## **Vehicle Safety Recall - Technical Service Bulletin**

**Attention:** McNeilus Product Owner  
**Subject:** Twin Vertical CNG with Luxfer Valves  
**Models Affected:** Bridgemaster RDM, Standard RDM, S-Series FDM  
**Model Year:** 2016-2018  
**Date:** January 2019

**PROCEDURE: Remove and replace Luxfer valves with another valve and specific fittings**

Figure 1

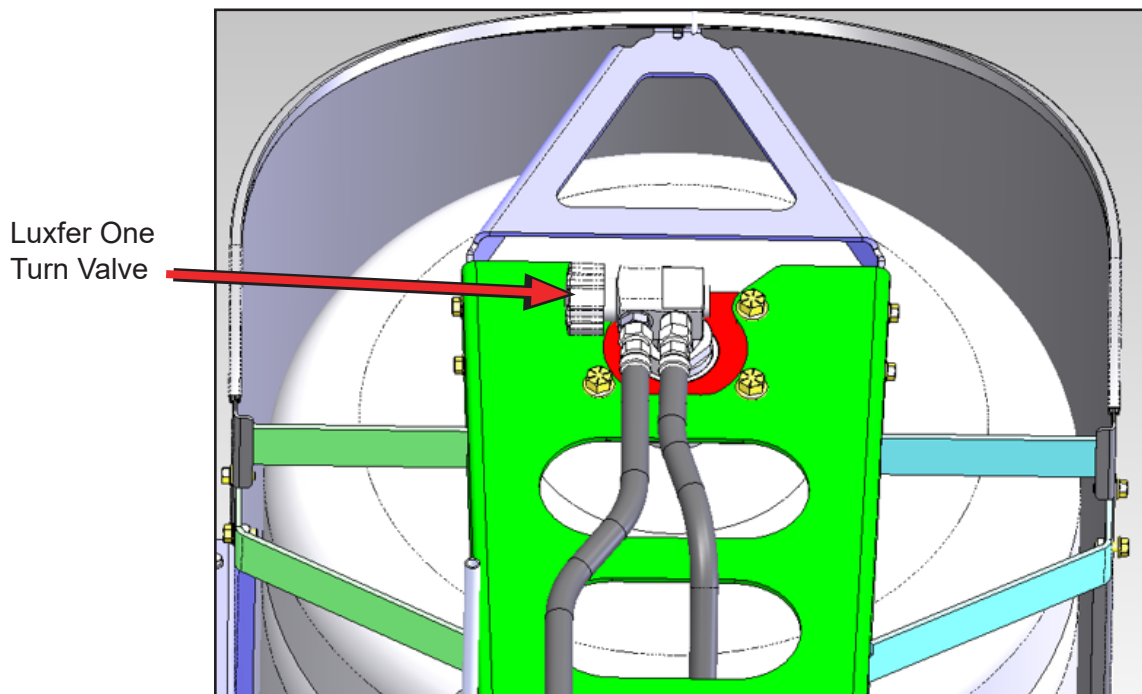
4. Refer to the illustration in Figure 1 to disconnect the hoses and remove the Luxfer valve and highlighted fittings (highlighted in blue) from both CNG tanks in the system for the rear discharge mixer. Discard the Luxfer valves.

Figure 2

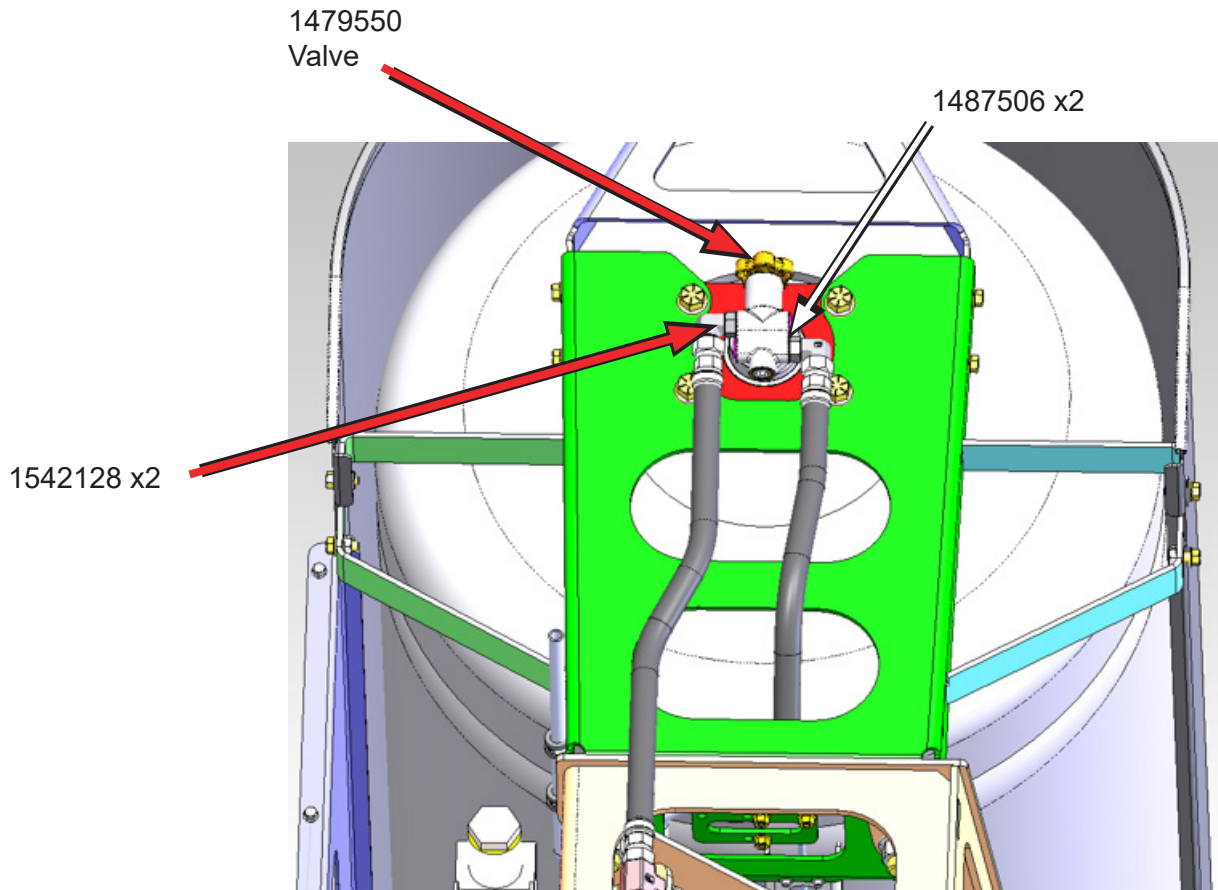
5. Install replacement fittings, plugs, and new OMB valves according to the illustration below (Figure 2) on each tank.
6. Reconnect the hoses. **NOTE:** The PRD vent hose connects to the live port and the tank hose connects to the tank feed port.

7. Use a torque wrench to torque the fittings to 60 ft.-lbs and the valve to the tank to 80 ft.-lbs.
8. Open all manual shut-off valves on the CNG tanks.
